Responses-to-Comments

**Proposed Temporary Shop and Services and Eating Place with Ancillary Facilities
for a Period of 6 Years in “Village Type Development” Zone
Lot 820 RP in D.D. 132, Tuen Mun, New Territories**

(Application No. A/TM/590)

DWG NO.	VER.
PLAN 1	001

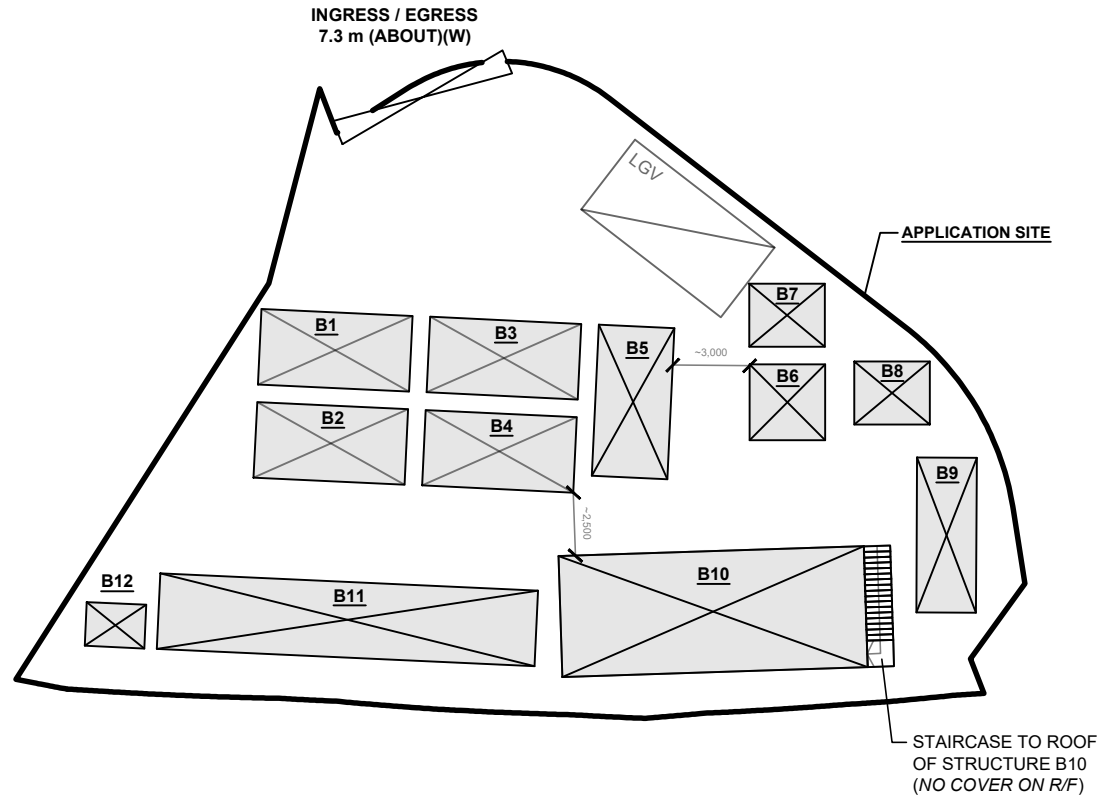
(i) The operation hours are revised to 12:00 pm to 11:00 pm daily, including public holidays. The layout of the proposed development is revised to meet the operational need (**Plan 1**).

Annex I - Nearby Private Fee-Paying Vehicle Park

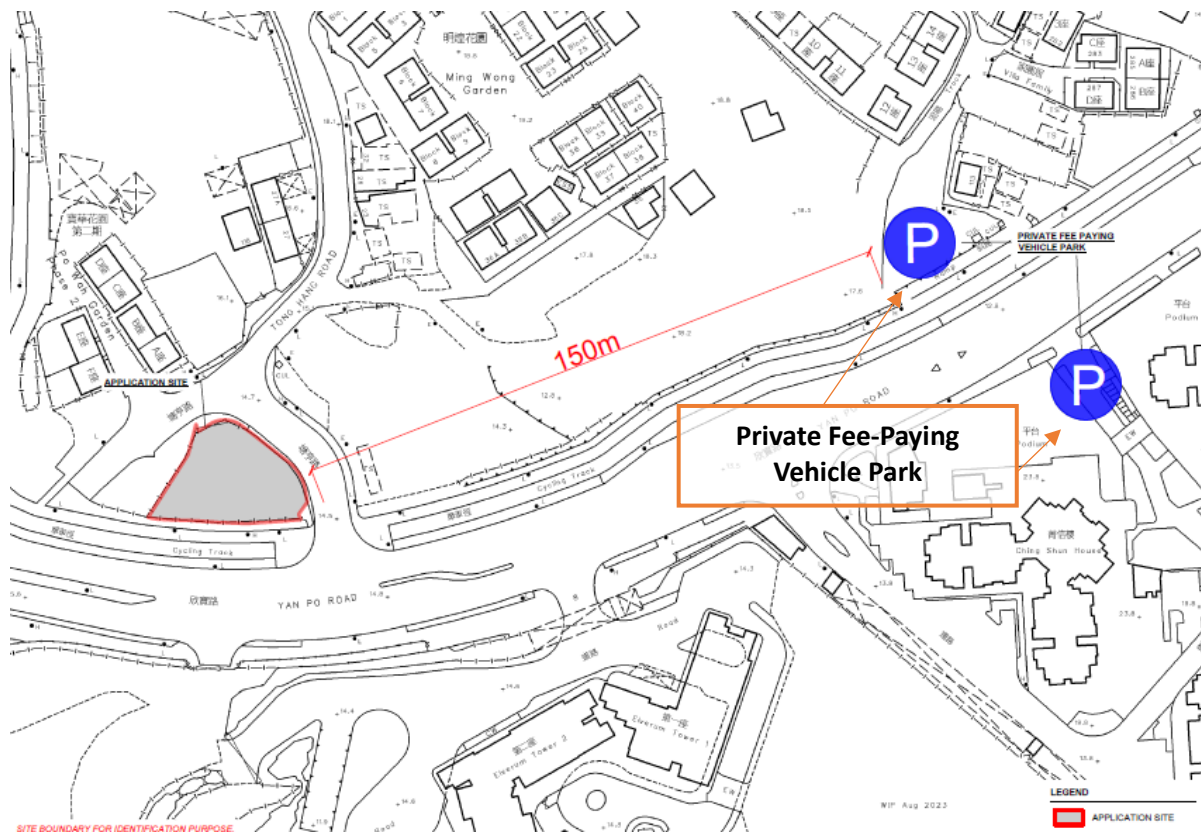
(a)	Further to R-t-C item (c), please clarify whether the mentioned private car parks in vicinity to the Site have provided adequate parking spaces for visitors, as these private car parks may not offer hourly parking.	Noted. A revised plan showing the nearby private fee-paying car parks is provided (Annex I). The nearest private fee-paying vehicle park is approximately 150m from the application site (the Site). As the Site is easily accessible by public transport services and private fee-paying vehicle parks, it is considered sufficient to accommodate the parking demand for the proposed development.

(c)	Based on the enclosed photos, the Site is currently serving as a temporary parking lot. If the Site is converted into temporary shop and services and eating place, please clarify how the local parking demand can	As private fee-paying vehicle parks are provided in the vicinity of the Site to accommodate parking demand, illegal parking is therefore not anticipated (Annex I).

- (i) Private fee-paying vehicle parks are provided in the vicinity of the Site to meet the parking need in case visitors commute to the Site by vehicle, details are as follows:
